V2500 A1/A5 SERIES PROPULSION SYSTEM SERVICE BULLETIN

This document transmits Revision 1 to Service Bulletin NV2500-78-0219

Reason for change
To change the
Accomplishment Instruction.

NACELLE – FIXED DUCT ASSEMBLY – LOWER BIFURCATION SEAL LAND GAP INSPECTION

Lower Bifurcation Seal Land Area Gap Inspection
Figure 1

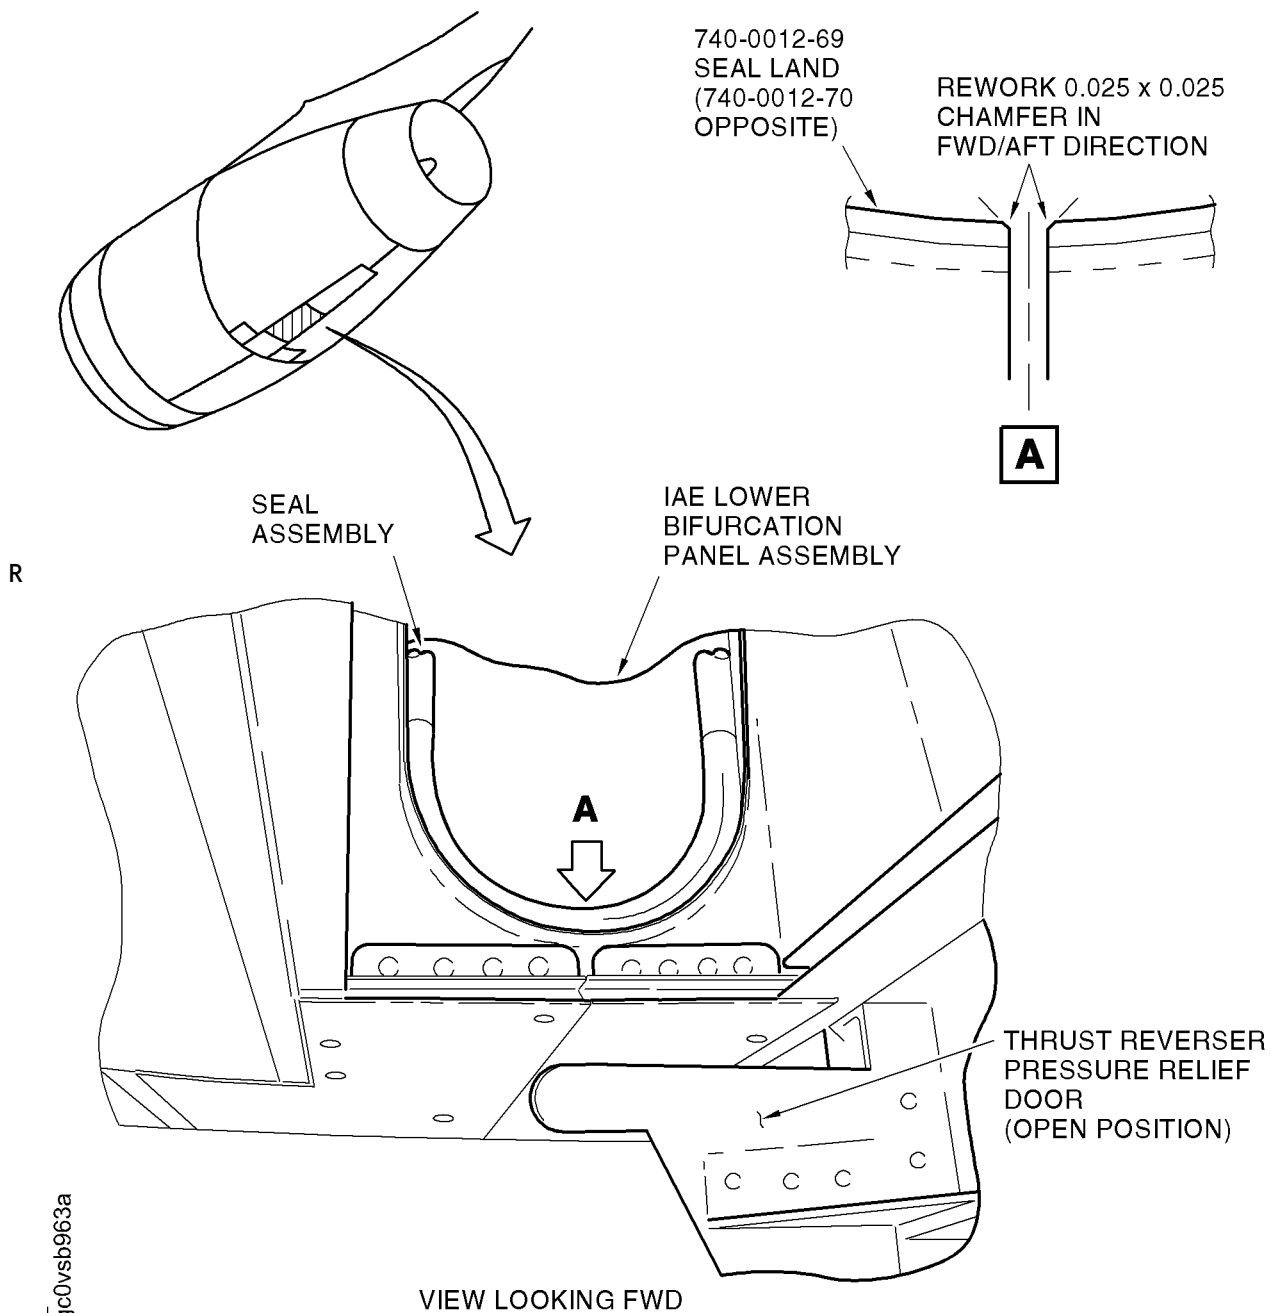
- (1) Inspect the lower bifurcation seal land area for damage to the seal on the bifurcation panel assembly (PN 6A7930). Refer to Figure 1. If seal is damaged, refer to VRS6669 for repair/replacement instructions.

R (b) Use local handtools to remove equal amounts of material from each seal land (P/Ns 740-0012-69 and 740-0012-70) to achieve an 0.080 - 0.120 inch (2,032 mm to 3,048 mm) gap.

R (c) Rework each C-duct half by adding a 0.025 x 0.025 inch chamfer in the forward/aft direction to the seal land. Remove all burrs and sharp edges to achieve a 125 microfinish using Comat 05-074 Aluminimu Oxide abrasive paper (180 grit).
